FAQ Title NFPA 805 Monitoring

Plant: Harris Nuclear Plant **Date:** January 13, 2012
Contact: Joelle DeJoseph/ Dave Miskiewicz **Phone:** 919-546-6247
Email: joelle.dejoseph@pgnmail.com

The purpose of this FAQ is to clarify the following for the NFPA 805 monitoring program:

Figure E-1 – NFPA 805 Monitoring Process

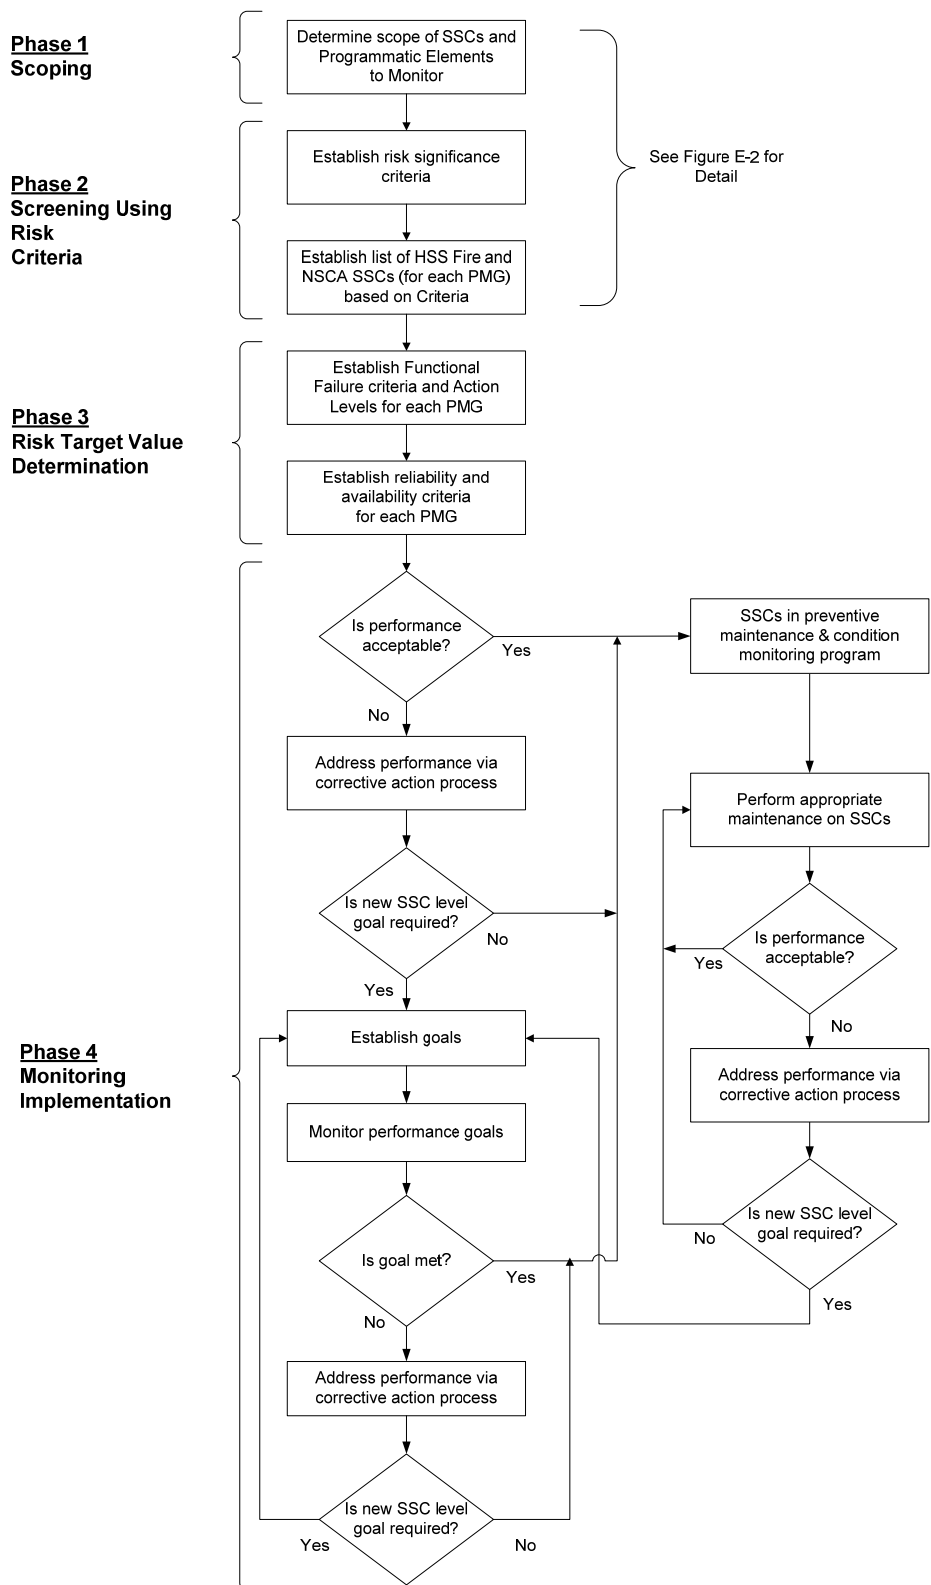
REPLACE ALL OF APPENDIX E WITH THE FOLLOWING:

A suggested methodology is outlined below. Figure E-1 provides an overview of the Monitoring Process, while Figure E-2 provides detail on a process for Phases 1 and 2.
